Questions & Answers

Horns Rev 3

Figure 1 Positive sequence impedance and angle seen from the 33 kV busbar at HRC.

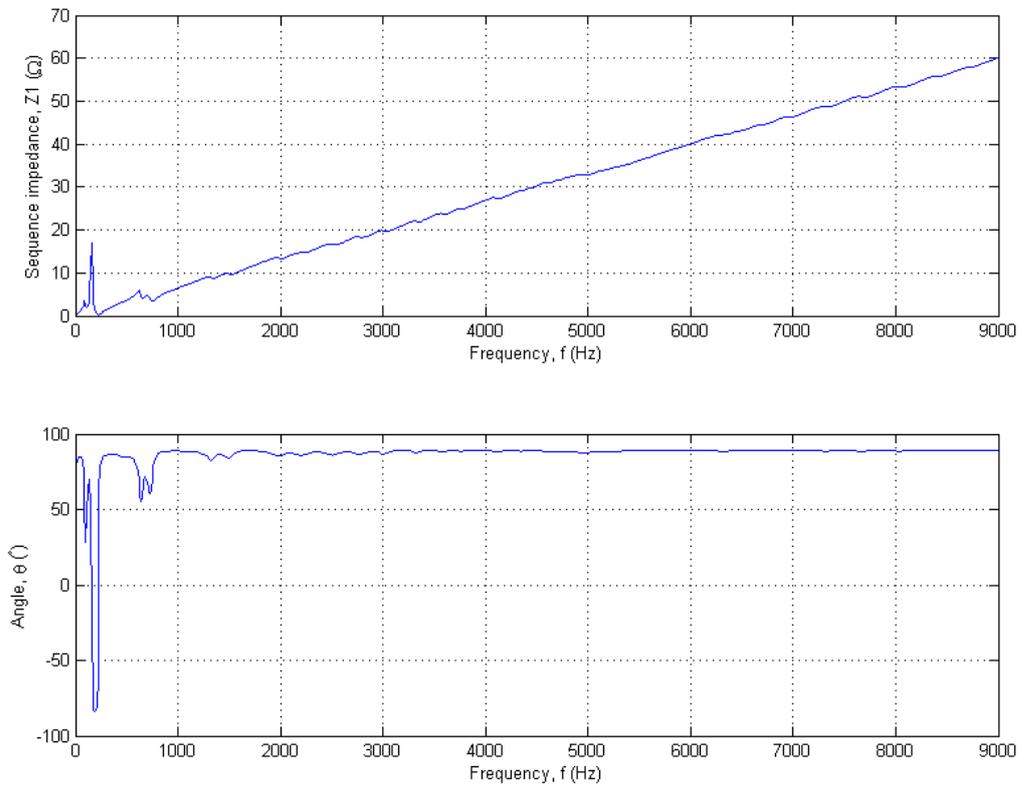
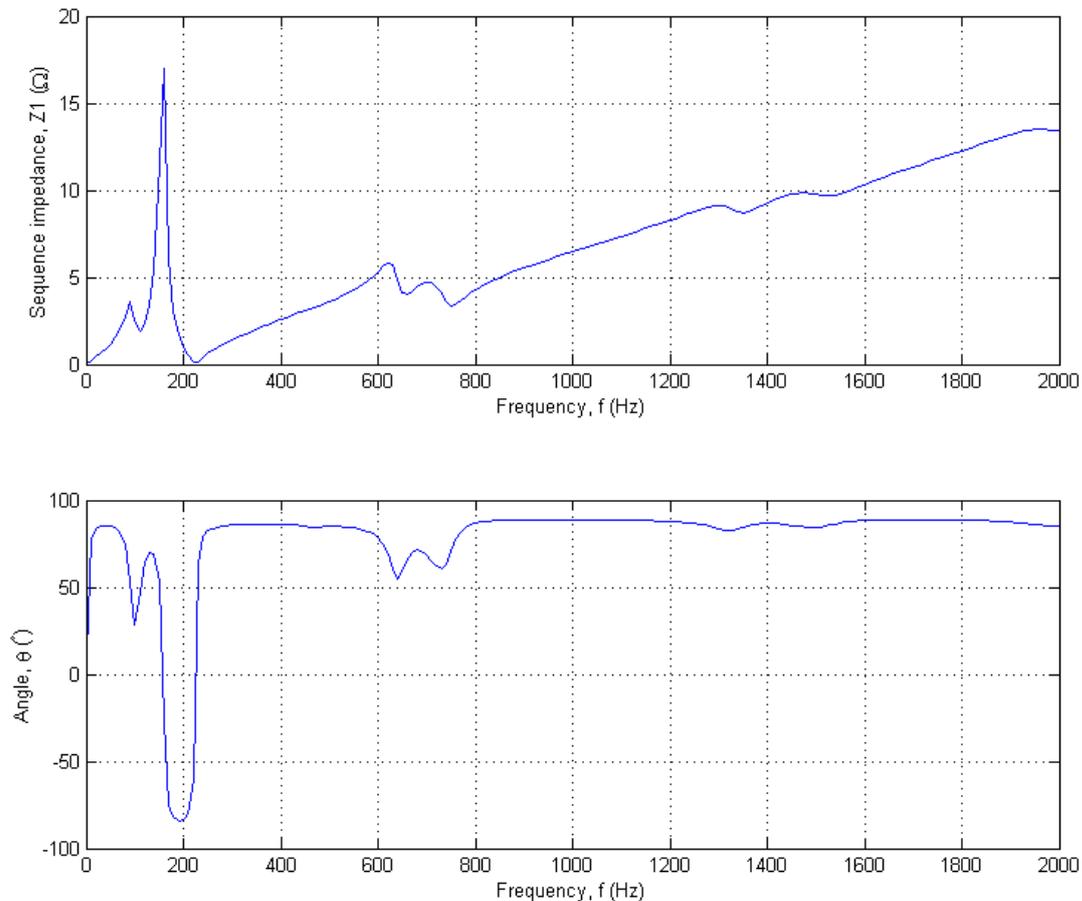
Q: To our understanding the facility owner can only take the responsibility towards the system grid code compliance – including understanding the influence of the relevant grid design data: offshore substation, export cables, onshore grid, etc – if all relevant system design data are given to all Prequalified Tenderers in due time for their detailed design and thus in reasonable time prior to final bid. We would request the TSO answer to how this will be handled prior to preliminary bid.

A (16.09.2014): Below a plot of the positive sequence impedance as seen from the 33 kV busbar HRC into the 220/33 kV transformers is supplied. The plot is based on calculations in PSCAD with the current design setup for the 220 kV transmission grid (parameters may change as more information is available on transformers, cables, etc.).

Positive and negative sequence impedances are identical. Zero sequence impedance will be infinite due to the delta winding on the low voltage side of the transformer.

Figure 4.1. Overview of air traffic interests at Horns Rev 3.

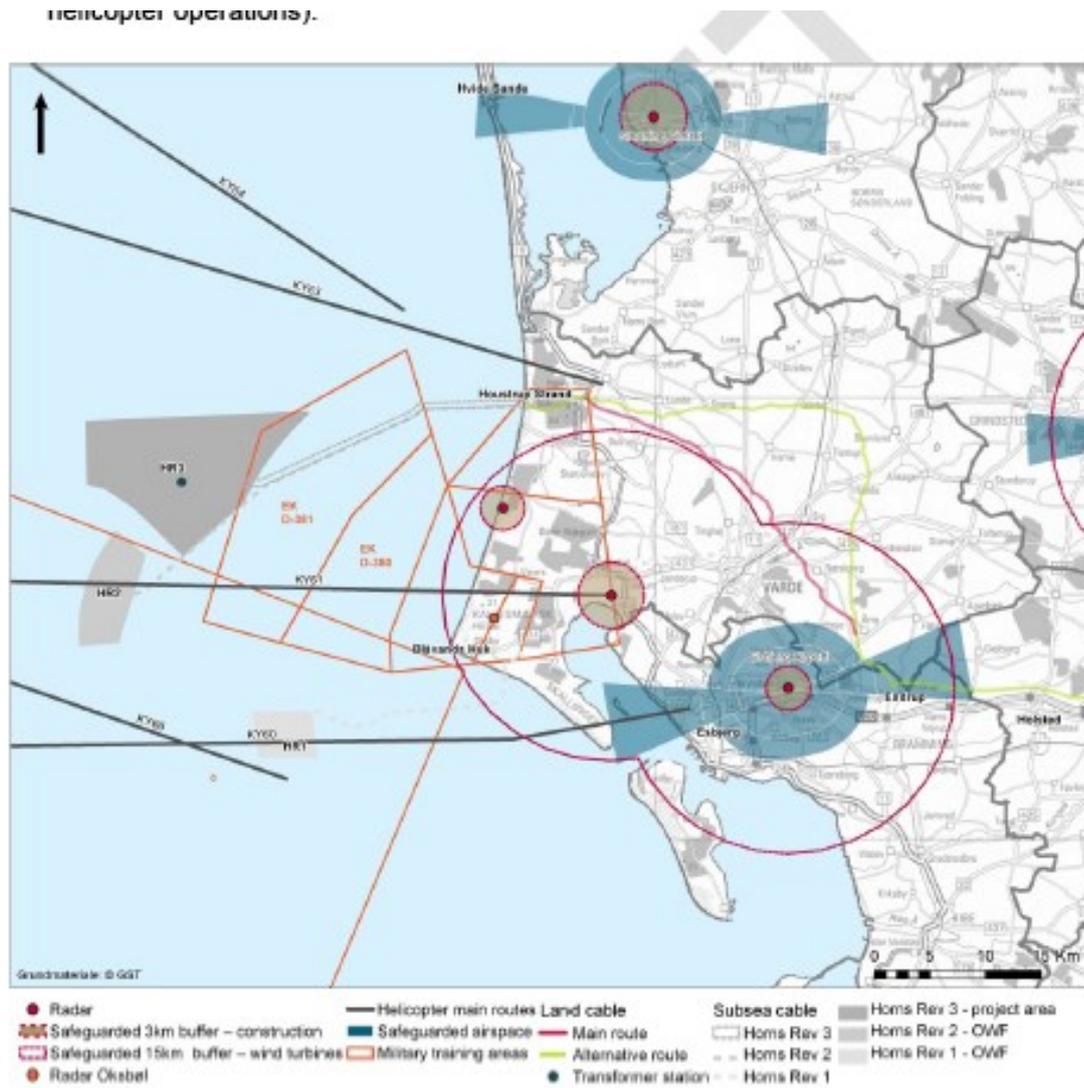
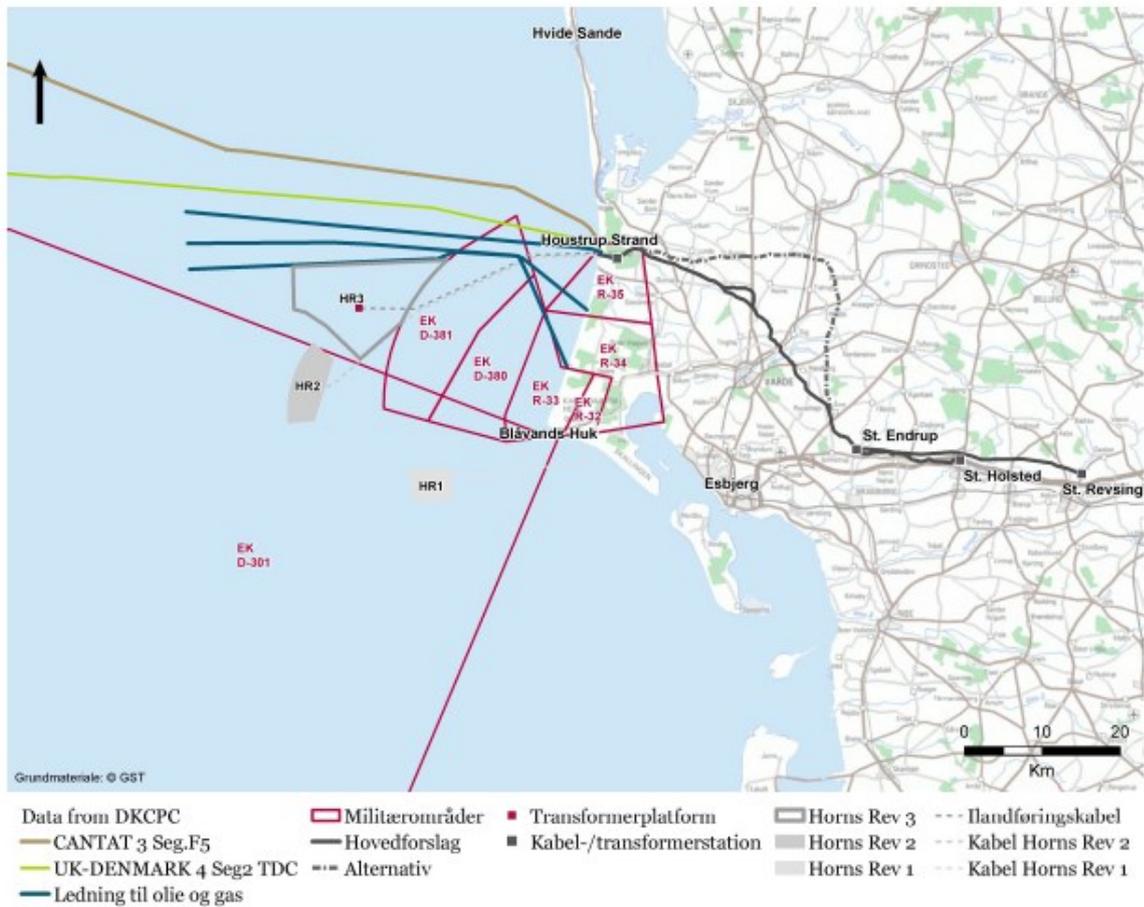
Q: As far as the position of the military area is concerning we have received GIS data demarcating the exact area, cp. map. from HR3-TR-023 v2 page 10:

However, in the EIS we find a different map of EK D-381, where the area does not overlap with the pre-investigation area for Horns Rev 3, cp. map from Part 2 – The Marine Environment – page 83:

Which demarcation of EK D-381 is the correct one?

A (30.06.2014): Map number two is the correct one.

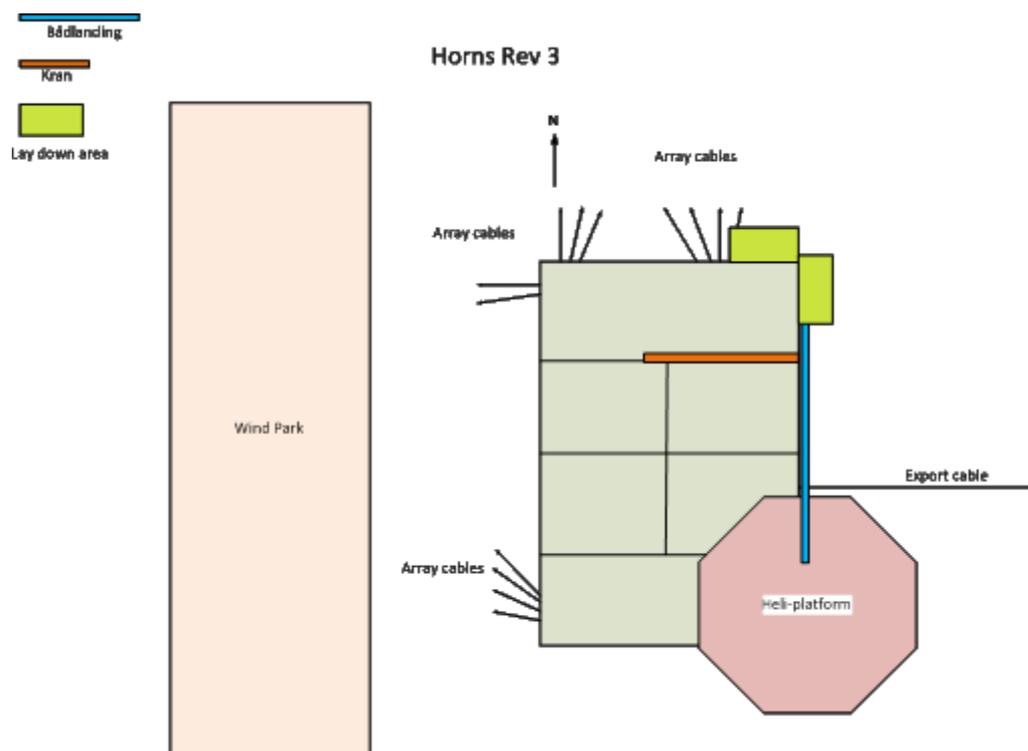
Q: Can ENS publish detailed substation J-tube drawings with orientation (North, south, east, west) direction on the drawings?

A (19.06.2014): Horns Rev 3: The orientation of the J-tubes at Horns Rev 3 platform is shown in the sketch below.

The wind park can be all way around the platform, here only indicated on the west side of the platform. However, array cables and wind turbines must be placed outside the corridor for the export cable which runs from the platform to land.
